SUBJECT: COMANCHE PEAK NUCLEAR POWER PLANT, UNITS 3 AND 4
DOCKET NUMBERS 52-034 AND 52-035
SUPPLEMENTAL INFORMATION FOR THE RESPONSE TO REQUEST FOR
ADDITIONAL INFORMATION NO. 1889

**Supplemental Response to
Request for Additional Information No. 1889 (CP RAI #11)**

RAI NO.: 1889 (CP RAI #11)

SRP SECTION: 02.05.02 – VIBRATORY GROUND MOTION

Figure 2.5.2-221 0.5 Hz Rock Seismic Hazard Curves for all Sources and for New Madrid Faults Alone

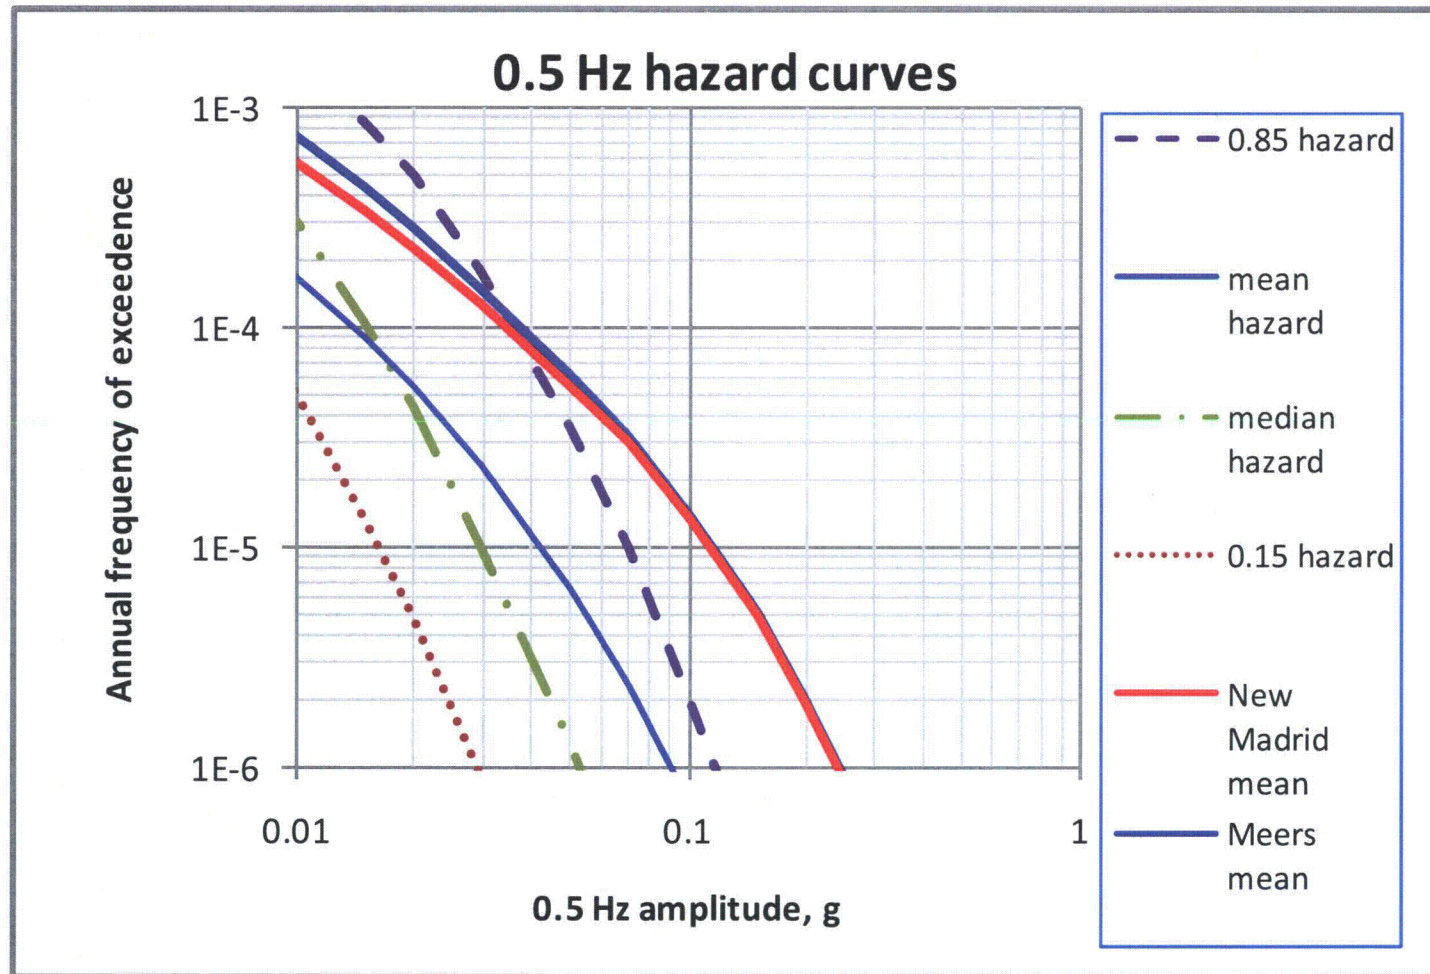
The Meers fault is about 270 km from the CPNPP site with an Mmax distribution of 6.85 ± 0.15 (Table 2.5.2-213) and a dominant recurrence interval of 1265 years. Considering these parameters, the staff is unclear why the Meers source's contribution to mean hazard is almost invisible in the 1 to 2.5 Hz deaggregations, and only a small contributor to the 5 to 10 Hz deaggregations of Figures 2.5.2-223 to 227. Please explain the near invisibility of the Meers source in FSAR Figures 2.5.2-223 to 227.

Figures 2.5.2-215 through 2.5.2-221 show total rock hazard as the mean, 15th, 50th, and 85th fractile curves for the EPRI-SOG sources plus the Meers fault and New Madrid faults, using the EPRI ground motion equations (Reference 2.5-401) with the EPRI aleatory uncertainties (Reference 2.5-403) and no CAV filter. The total mean and fractile rock hazard curves are shown for all sources. In addition, the mean hazard from the New Madrid faults is shown (this is included in the total curves). The Meers fault and New Madrid faults dominate the hazard for frequencies of 5 Hz and lower, and contribute a significant part of the hazard for 10 Hz amplitudes and higher. One of the characteristics of the hazard curves at low spectral frequencies (2.5 Hz and lower) is that the mean rock hazard curves exceeded the 85th fractile at high ground motion amplitudes. This exceedance occurs because the New Madrid seismic source dominates the hazard, and is caused by a few EPRI ground motion equations (Reference 2.5-401) indicating relatively high hazards for the large distance between the New Madrid seismic source and the CPNPP Units 3 and 4 site.
